Mary Ave Villas Project

Supplemental Report

CITY COUNCIL STAFF REPORT SUPPLEMENTAL

Meeting: February 3, 2026

EXISTING CONDITIONS & DEMO PLAN

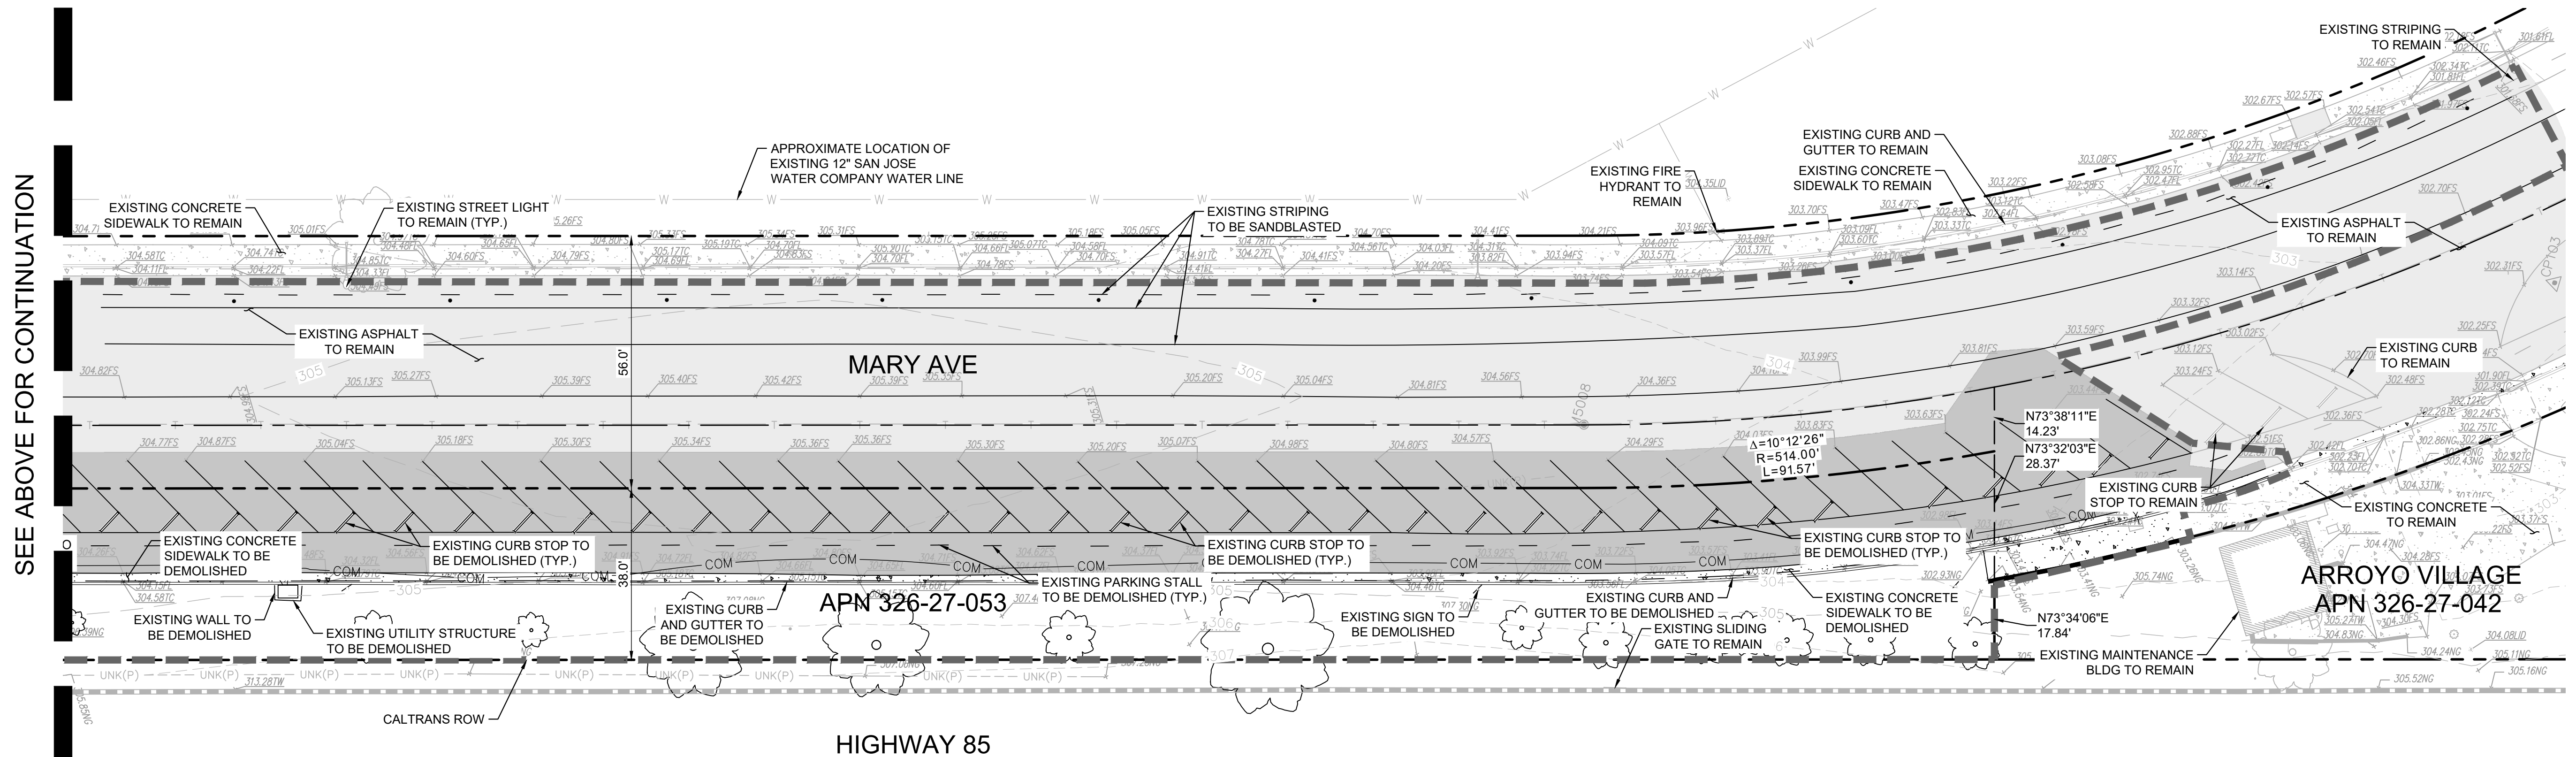
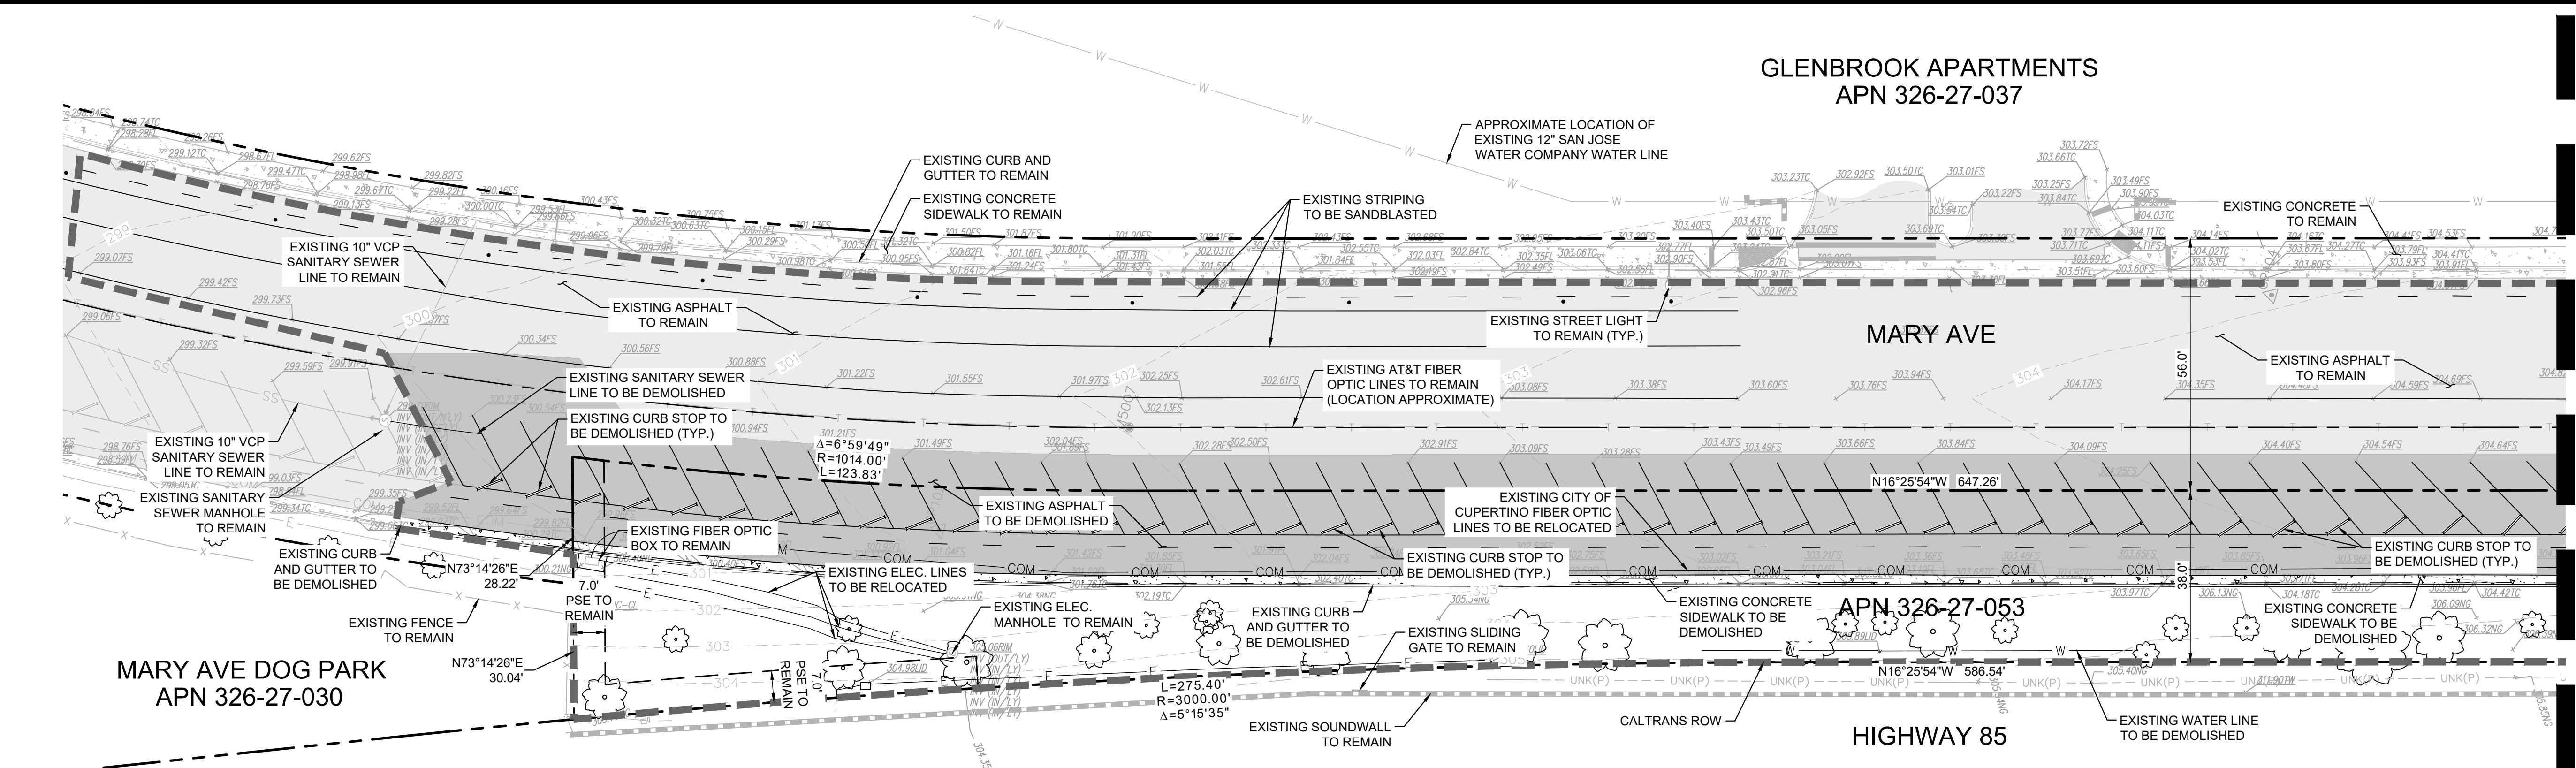
Q4: What exactly would be reconfiguration of the Mary Avenue? Please provide clear images for before and after.

Q5: What exactly are the existing parking spots and what exactly are the new ones? Please provide clear images for before and after.

Q6: What exactly would be vacated from the Public Right of Ways? There was no map included in this agenda and no map of the Public Right of Ways on to be vacated the 1/27 Planning Commission agenda. It's unclear what exactly is the dimension of the Public Right of Way to be vacated.

Staff response: The Plan Set provided with the Staff Report (Attachment F) showed the existing conditions as well as the proposed layout of the Mary Avenue Right-of-Way. Supplemental Attachment G shows sheets C000.0 (Existing Conditions and Demolition Plan), C001.0 (Preliminary Site Plan), and C005.0 (Sections), which had been included in the Plan Set that had been provided with the Staff Report.

Staff response: Sheet C000.0 shows the property line of the parcel to be vacated (Supplemental Attachment G). Further, Supplemental Attachment H (Parcel Map) shows a clean dimensioned parcel without the proposed development and/or existing conditions overlaying onto the sheet.
